SURRY POWER STATION, UNIT NO. 1

AMENDMENT TO FACILITY OPERATING LICENSE

Amendment No. 69
License No. DPR-32

SAFETY EVALUATION BY THE OFFICE OF NUCLEAR REACTOR REGULATION
RELATED TO AMENDMENT NO. 69 TO FACILITY OPERATING LICENSE NO. DPR-32
AND AMENDMENT NO. 69 TO FACILITY OPERATING LICENSE NO. DPR-37

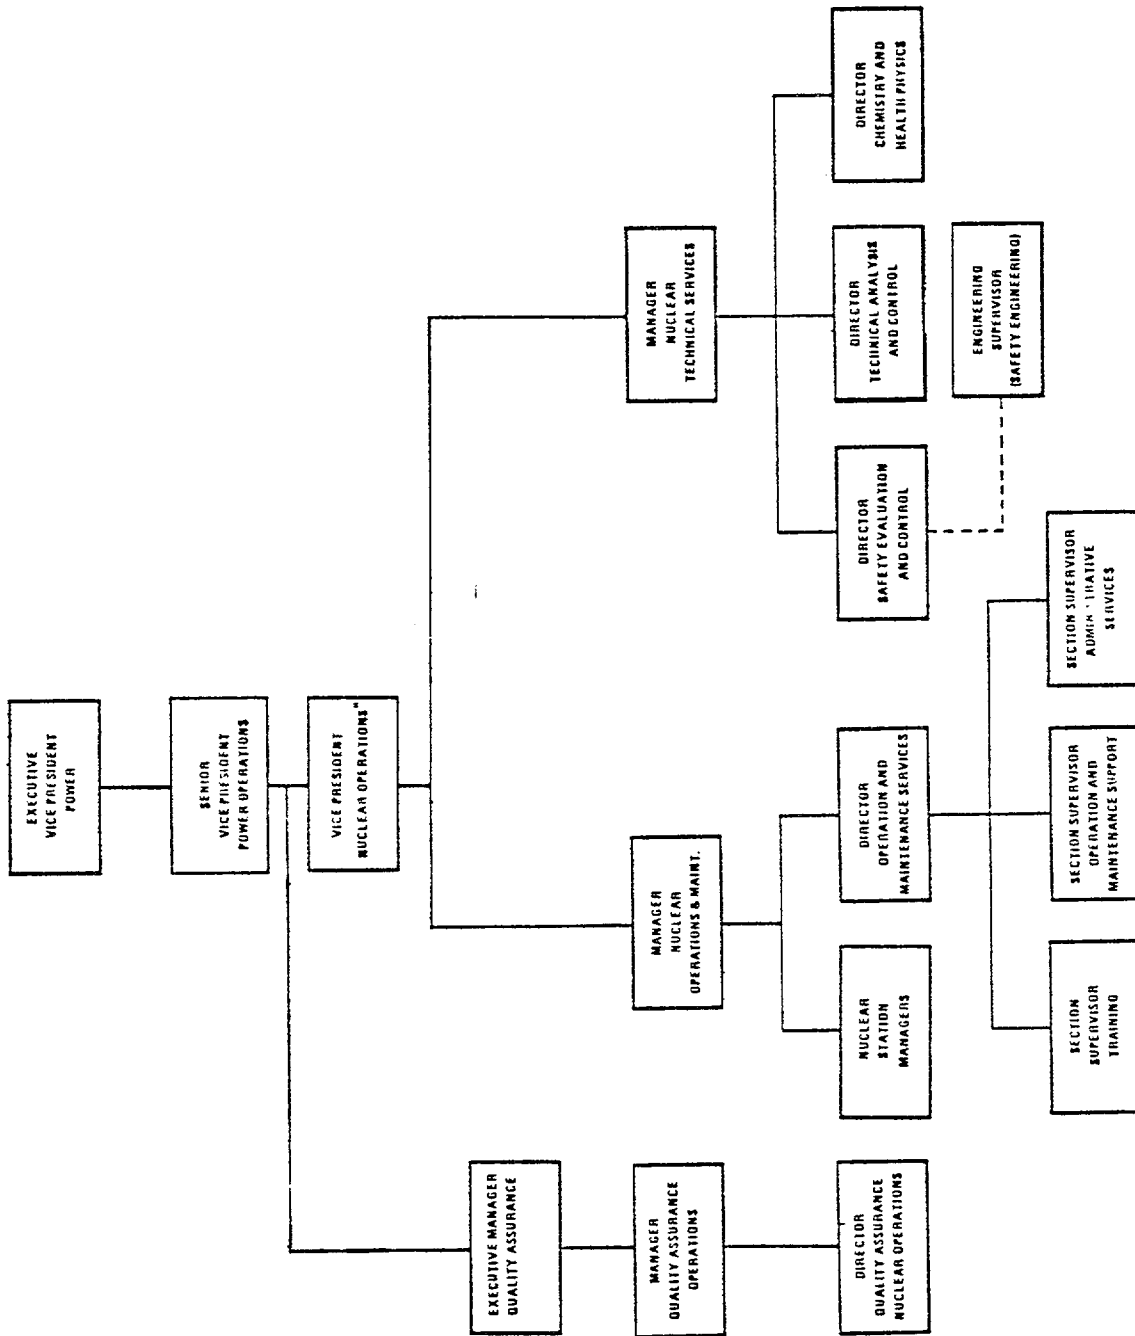
Technical Specifications Figure 6.1-1 has been revised to show the new structure of the offsite organization for facility management and technical support. Information provided by Figure 6.1-1 was previously provided by Figures 6.1-1 and 6.1-2. The previous positions of Senior Vice President-Power and Vice President-Power Supply and Production Operations have been deleted from the Technical Specifications. The deleted positions have been replaced by the Executive Vice President-Power, the Senior Vice President-Power Operations, and the Vice President-Nuclear Operations. All previous references to the Senior Vice President-Power and Vice President-Power Supply and Production Operations positions have been revised to reference either the Senior Vice President-Power Operations or the Vice President-Nuclear Operations positions.

As indicated by Figure 6.1-1, the Manager-Nuclear Operations and Maintenance and the Manager-Nuclear Technical Services replace the previous position of Director-Nuclear Operations. Both managers will report to the Vice President-Nuclear Operations. The Manager-Nuclear Operations and Maintenance has responsibility for the supervision of the Nuclear Station Managers. Both Nuclear Station Managers and the Director-Operation and Maintenance Services report to the Manager-Nuclear Operations and Maintenance. The Section Supervisor-Training, the Section Supervisor-Operation and Maintenance Support, and the Section Supervisor - Administrative Services will report to the Director-Operation and Maintenance Services. Reporting to the Manager-Nuclear Technical Services are the Director-Chemistry and Health Physics, the Director-Technical Analysis and Control, and the Director-Safety Evaluation and Control.

The organization charts for the Appendix "A" Technical Specifications for Surry have been revised to reflect the restructuring of the Quality Assurance Department and changes to other organization titles. The previous title of Executive Manager-Licensing and Quality Assurance has been revised to Executive Manager-Quality Assurance. In addition, the positions of Manager-Quality Assurance, Operations and Director-Quality Assurance, Nuclear Operations are shown on the organization chart. |

1. The offsite organization for facility management and technical support shall be as shown on TS Figure 6.1-1.

SURRY POWER STATION
ORGANIZATION CHART

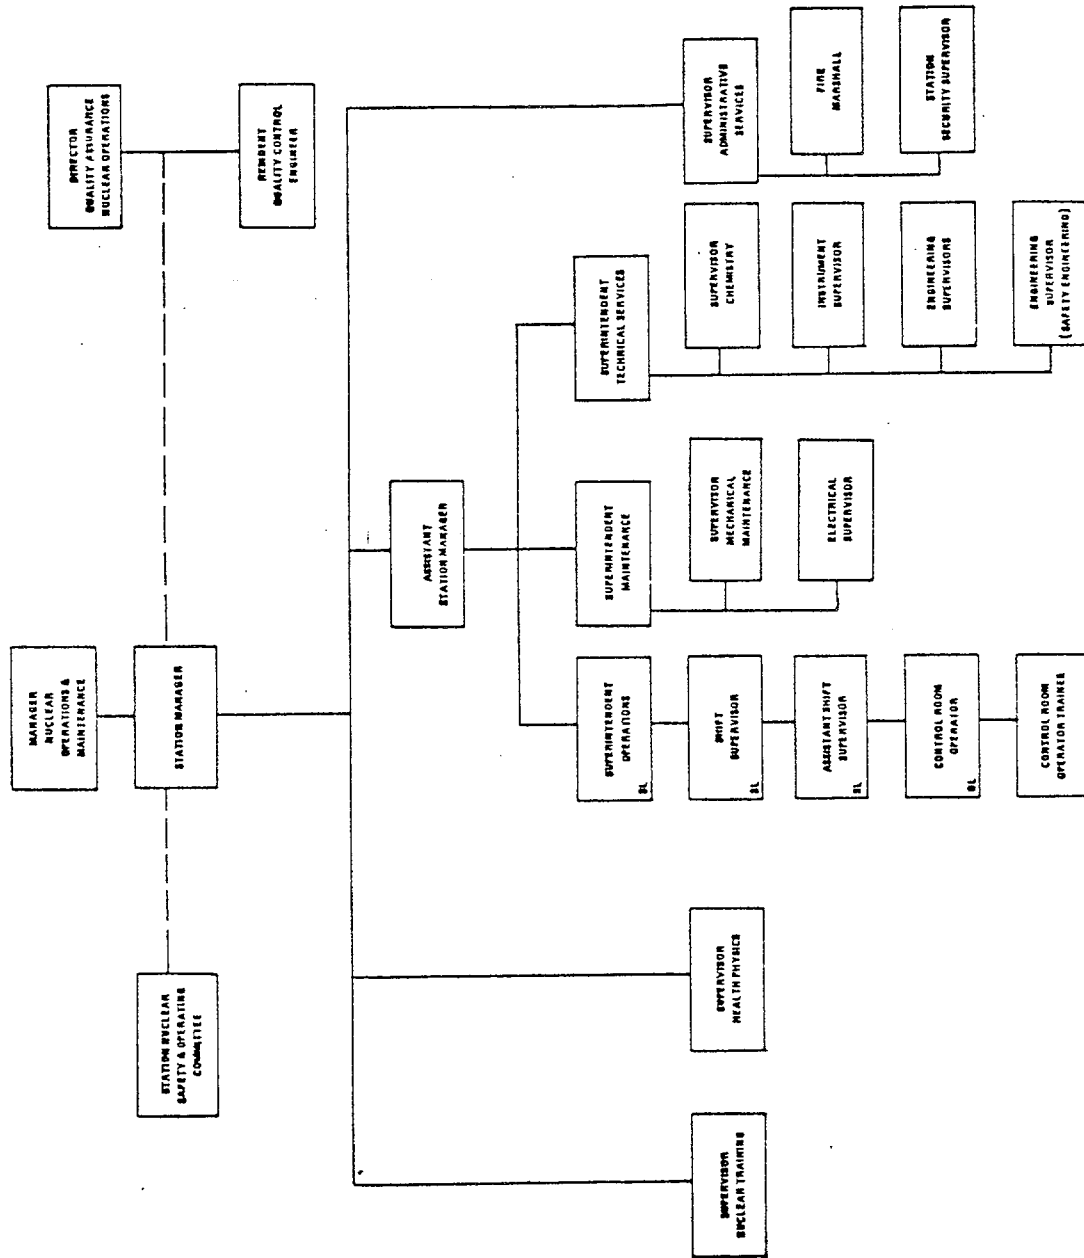
Technical Specification Figure 6.1-2 has been revised to show the new structure of the Surry Power Station organization. Figure 6.1-3, which previously provided this information, has been deleted. As explained above, the Station Manager reports to the Manager-Nuclear Operations and Maintenance. Our August 4, 1980 submittal (Serial No. 671) proposes revising Section 6.0 to add the new position of Assistant Station Manager to the Surry Power Station organization. The Assistant Station Manager will be directly responsible for the safe operation and maintenance of the power station. He will serve in a coordinating capacity to the Station Manager for the off-site activities of the Station. During the absence of the Station Manager, the Assistant Manager will act as the Station Manager. The Assistant Station Manager will also be the Vice Chairman of the Station Nuclear Safety and Operating Committee (SNSOC). The Superintendent-Operations, the Superintendent-Maintenance, and the Superintendent-Technical Services will report to the Assistant Station Manager. All three of these superintendents will remain members of the SNSOC.

The positions of Operating Supervisor and Auxiliary Operator have been eliminated from the organization chart. In addition, the position title of Assistant Control Room Operator has been revised to Control Room Operator Trainee. The positions of Maintenance Coordinator and Mechanical Supervisor have been replaced on the station organization chart by the position of Supervisor-Mechanical Maintenance. Both the Maintenance Coordinator and the Mechanical Supervisor report to the Supervisor-Mechanical Maintenance. Other title changes made to the organization chart include the change of Supervisor-Safety Engineering to Engineering Supervisor (Safety Engineering), the change of Engineering Supervisor to Engineering Supervisors to reflect the two positions of Engineering Supervisor-Performance and Tests and Engineering Supervisor-Design Changes and Projects and, the change of Training Supervisor to Supervisor-Nuclear Training. The Supervisor-Health Physics position has been shifted such that he will now report directly to the Station Manager instead of reporting to the Superintendent-Technical Services. The positions of Supervisor-Nuclear Training and Supervisor-Administrative Services will also report to the Station Manager.

B. The Station organization shall conform to the chart as shown on TS Figure 6.1-2.
